ADDENDUM NUMBER 2
PROJECT CODE: A0122-21-492426 and A0135-22-511452
IFB# 154542103

November 9, 2021

PROJECT: Virginia Tech
New Baseball Pitching Lab
Blacksburg, Virginia

P1.1

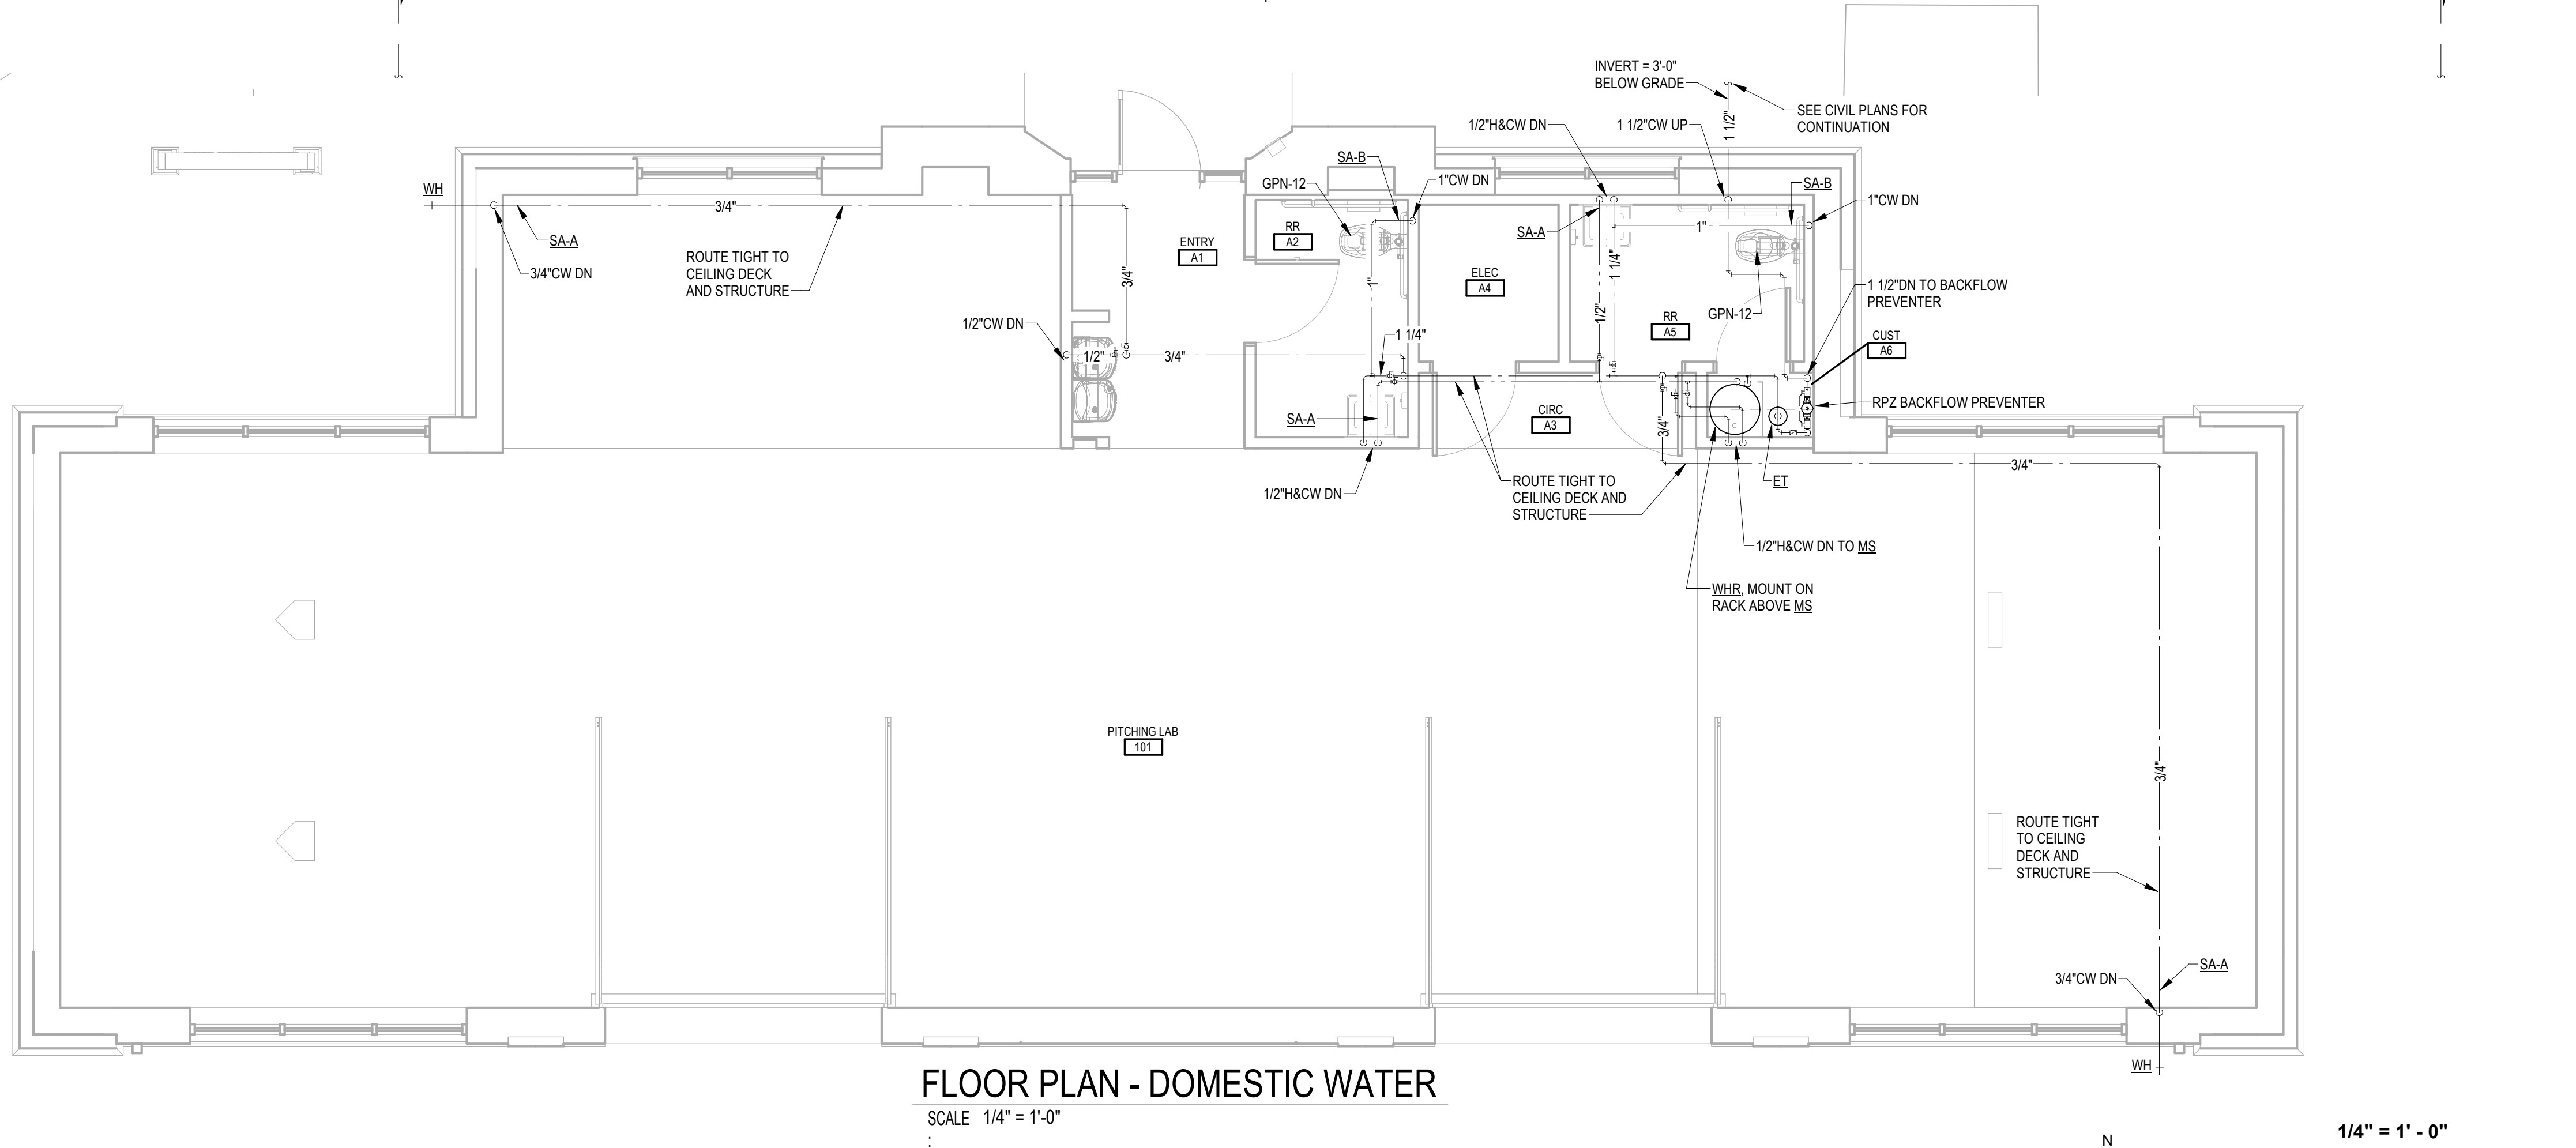
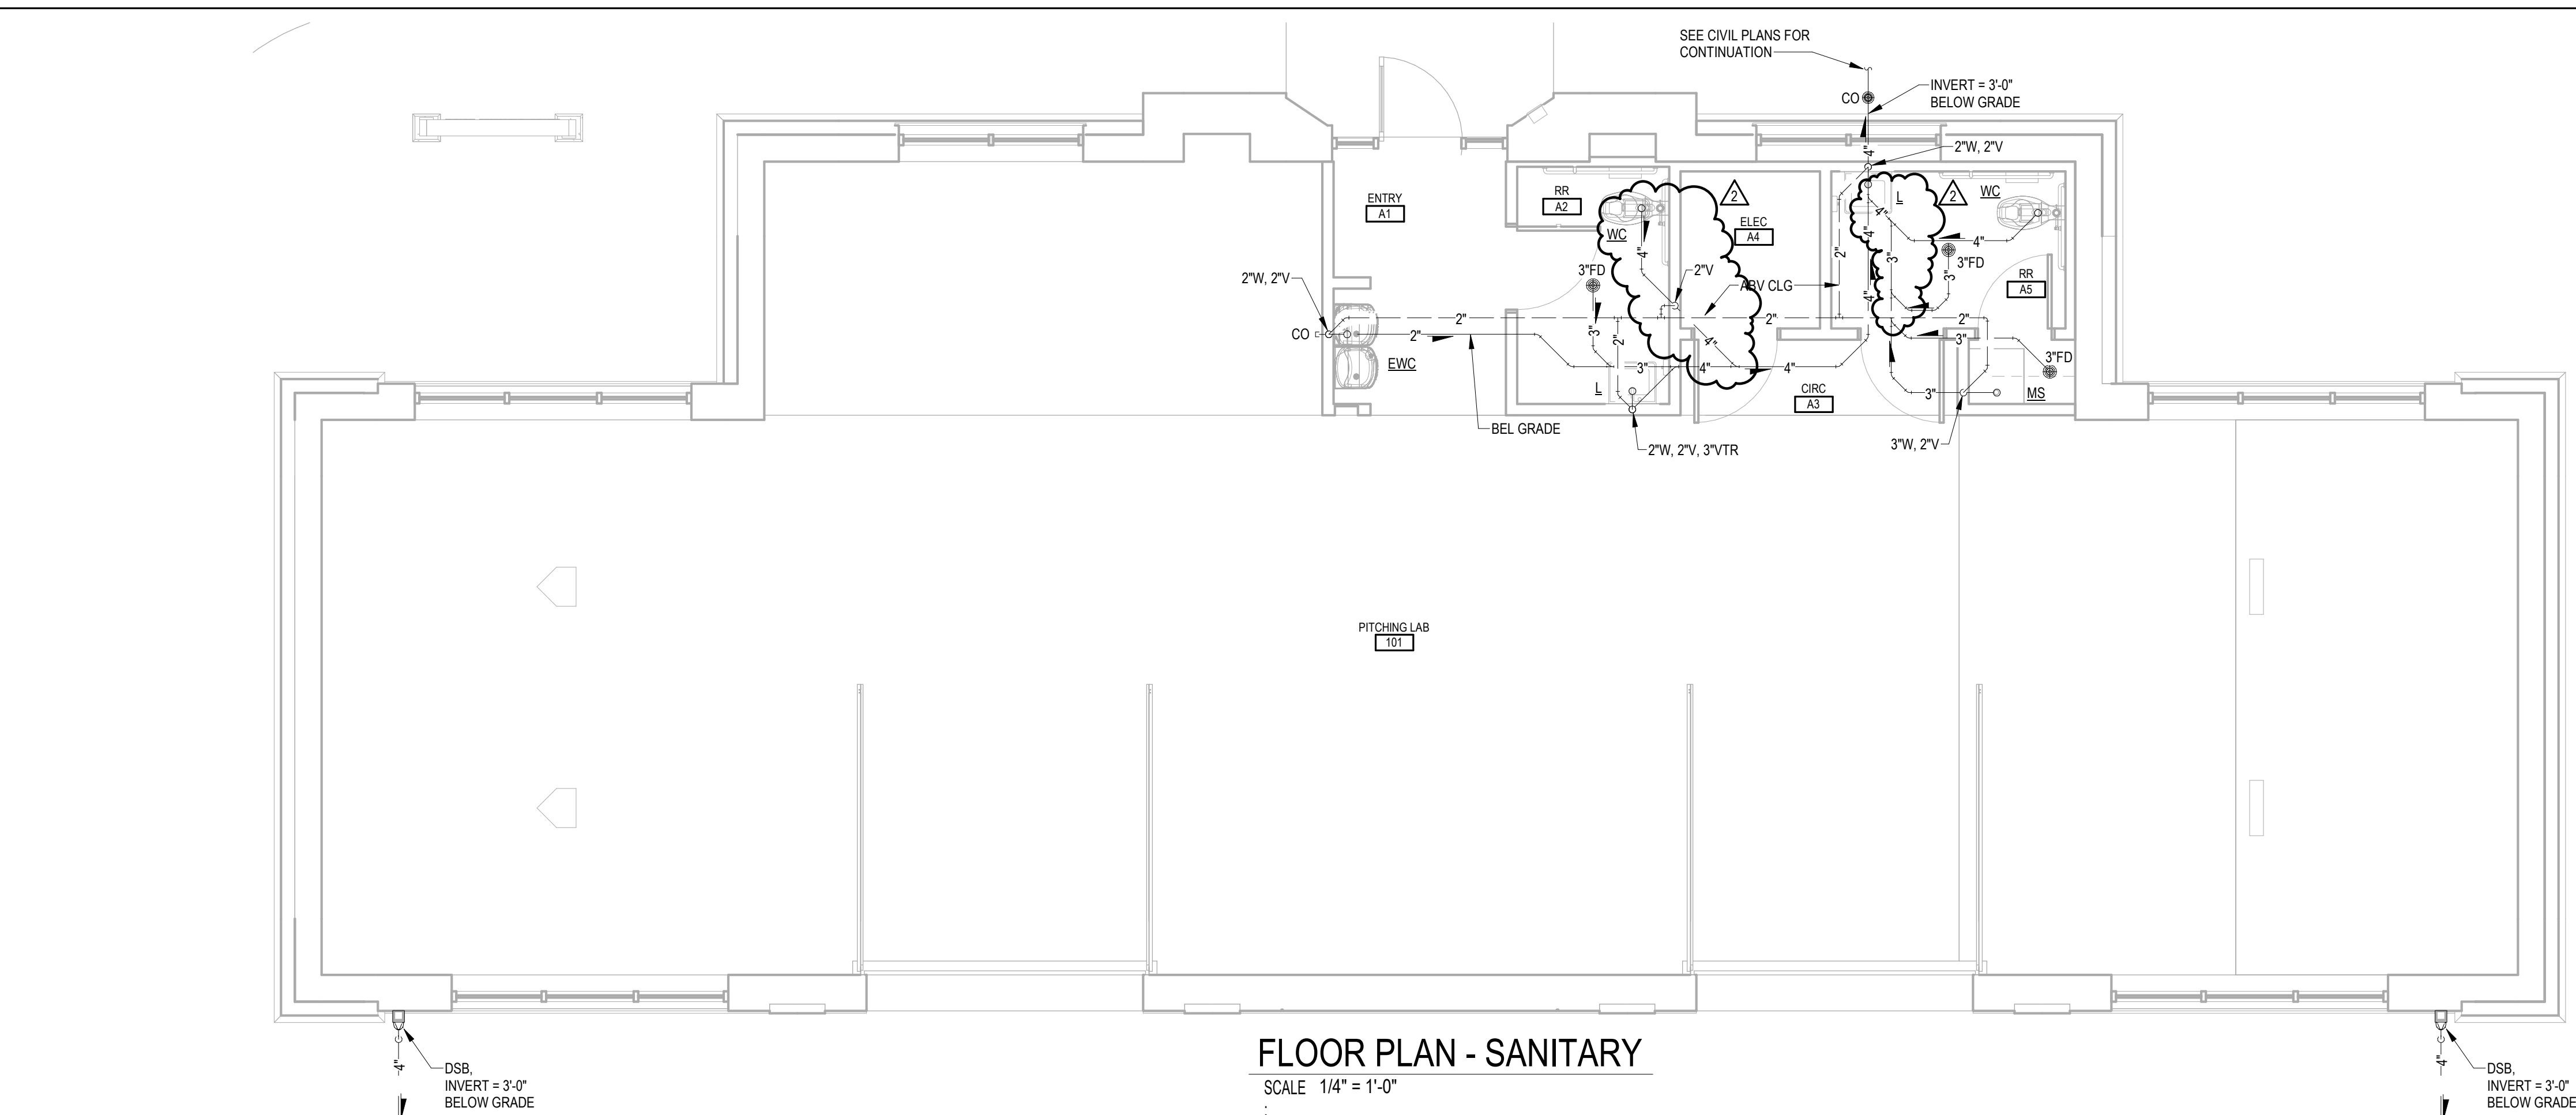
See attached P1.1 with revisions clouded.
